**Survey of Premises**

NO. 429 WELLINGTON AVE.  
BOROUGH OF HADDONFIELD  
CAMDEN Co. New Jersey

**Re: Bulk Variance**  
**Alice A. Previte**  
**429 Wellington Avenue (Block 88.03, Lot 2)**  
**Application #ZBA2022-35**  
**RVE #04-17-Z-099**

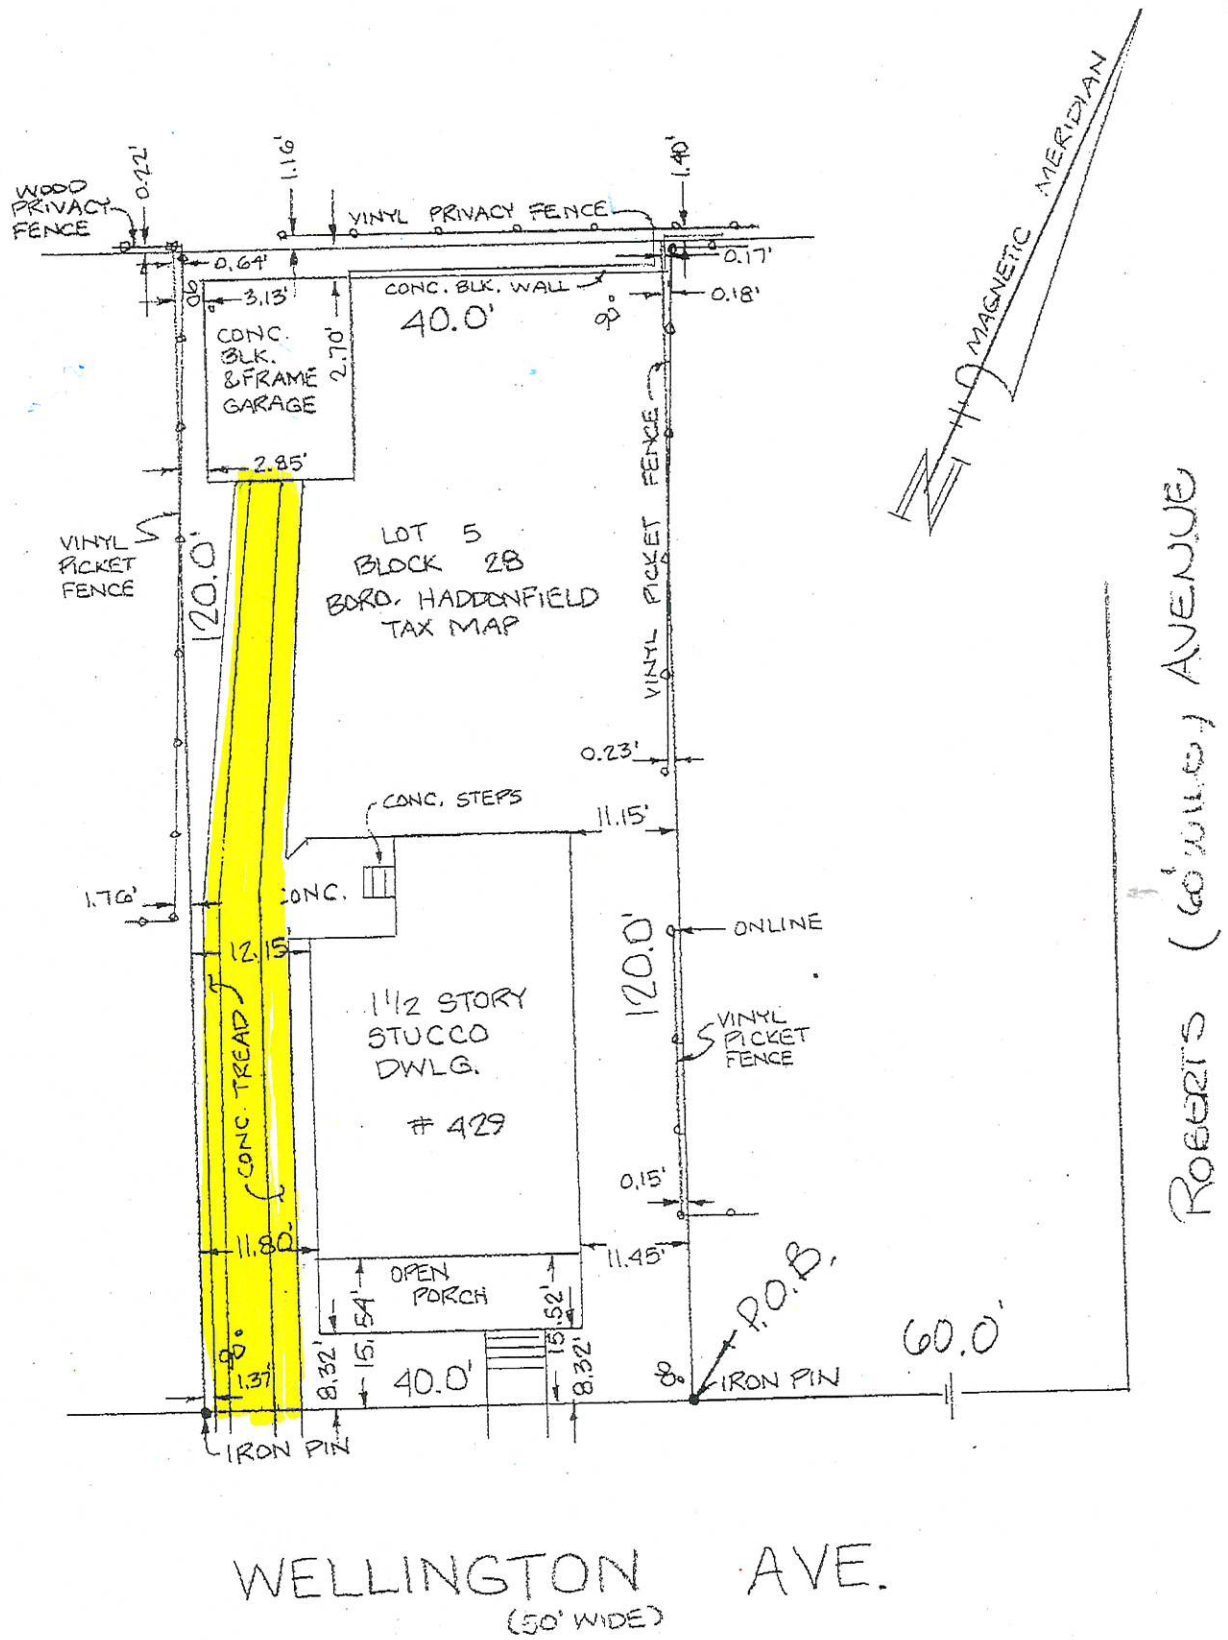
The survey of premises was prepared and signed by Richard S. Humphries, P.L.S., Walter H. Macnamara Assoc., Inc., 813 Haddon Avenue, Collingswood, New Jersey 08108, (856) 854-5229. The plan should be sealed by a licensed professional according to State Regulations.

1. While the tax map and the zoning schedule note a lot width and frontage of 50 feet, the survey shows the frontage is 40 feet. The applicant should provide testimony of the discrepancy.
2. The front yard setback shall be determined based Chapter 135, Attachment 7. An analysis has not been provided to determine the required setback which is determined based on the actual front yard setback of each lot within 200 feet and calculation of the average setback (including elimination of one high and one low value). In the event that the actual setbacks cannot be reasonably determined, 20 feet shall apply.

1. Per Section 135-32.D(4)(a), building coverage is limited to 25%, whereas 25.3% exists and 25.3% is proposed. This is a pre-existing condition.
2. Per Section 135-86.B(6)(a), driveways and other parking areas shall not be less than nine feet in width and shall be constructed with materials that are a hard surface such as concrete, asphalt, paving stones, bricks, landscaping pavers and/or other similar hard-surface materials. The applicant has proposed a driveway that is 8 ft. wide. The proposed material is to be indicated. The applicant requests a waiver.

3. Per Section 135-86.B(6)(b), except as set forth herein, all driveways shall be set back not less than three feet from the side lot line. The applicant is proposing a driveway that will be 1.37 ft. away from the lot line on the left side. The applicant requests a waiver.

4. A plot plan has not been provided showing the proposed material, location, or widths of the new driveway. Construction details are required for review.

5. We assume a new concrete driveway apron is proposed, but no details have been provided. A Road Opening Permit would be required for any work within the street right-of-way.
